Determination 2025/051

Compliance of an altered timber retaining wall with Clause B1 *Structure* and an associated surface water management system with Clause E1 *Surface water* for protection of other property

50A, 52 and 52A Jackson Terrace, Ranui, Porirua

Figure 3: Structural Engineer detail for the strengthening and addition to the original retaining wall (not to scale)

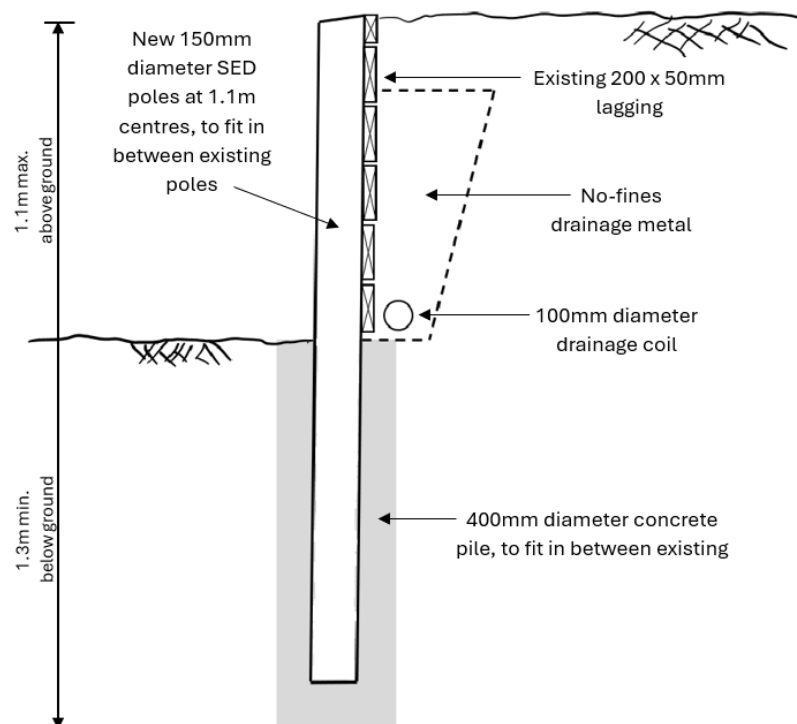
- 2.4. In 2018, during construction of the new dwelling 52A, it was identified that strengthening and additions were required to the original retaining wall. The structural engineer provided a construction detail (figure 3) specifying new 150 mm diameter timber poles at 1.1 metre centres “to fit in between existing poles”. These were to be set in 400mm diameter concrete piles to a minimum depth of 1.3m, supporting the existing 200mm x 50mm lagging to a height of 1.1m. Behind the lagging, there was to be drainage metal above and around a 100mm diameter drainage coil.

3. About half of the retaining wall has been constructed at this point. A few poles had been placed in the holes but they were not braced yet.
4. Piles were drilled to the correct diameter and at the correct centres as per detail sent through on 16/07/18. The depths are much deeper than specified on the detail as it was advised by the contractor that the piles were to be below the invert of the public drain [running north-south through the rear yard of 52 Jackson Terrace]. There [sic] piles depths are about 2.5m.

- 3.13.1. The full height/new posts are leaning away from the vertical (towards the lower property) by between 6.8 – 8.9 degrees along the length of the retaining wall, when the “standard requirement at time of construction was... 4 [degrees] leaning into [the] supported land”.

- 4.13. The evidence in this case demonstrates that the retaining wall was constructed near vertical, and I consider the evidence of the posts now being up to 170mm from the vertical in various locations along its length demonstrates the wall is deforming and losing equilibrium.

Figure 4: Surface water management system dish channel falling from two directions to the disposal sump

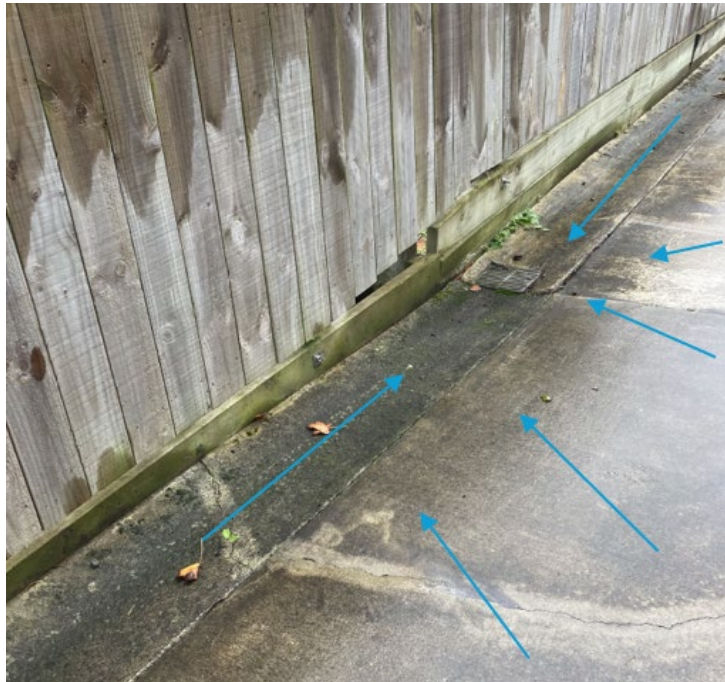
4.22. Considering the evidence as to how the system has been constructed, I am of the opinion the dish channel is inadequately sized and formed, and it is not sufficient to collect the surface water from an event having a 10% probability of occurring annually that is collected and concentrated by the building work on 52A Jackson Terrace. The dish channel is shallow and collects little water before overflowing, causing surface water to over-top of the retaining wall and flow down into the neighbour’s property. Therefore, I consider the surface water management system as constructed above the retaining wall does not perform to the level required by E1.3.1 with regard to avoiding likelihood of damage or nuisance to other property.

4.26. The evidence provided as well as what has been seen on the site visit shows that the deformation of the retaining wall has caused more space behind the wall for soils to settle and slump, causing cracking in the concrete driveway, and separation between the driveway and the dish channel, and between the dish channel and the top of the retaining wall.

4.27. The failure of the retaining wall is contributing to the failure of the surface water management system by limiting the amount of surface water able to reach the dish channel to then be appropriately disposed of to the sump. The dish channel is no longer collecting the surface water from the building work associated with the construction of the dwelling at 52A Jackson Terrace, with that water instead saturating soils behind the retaining wall before seeping out along the length of the front of the retaining wall onto 52 Jackson Terrace.

- 4.32. I consider the surface water management system above the retaining wall to collect and surface water from the building work associated with the dwelling at 52A Jackson Terrace as constructed, and with associated consequences of the structural failure of the retaining wall, does not comply with clause E1.3.1 in respect of protection of other property.
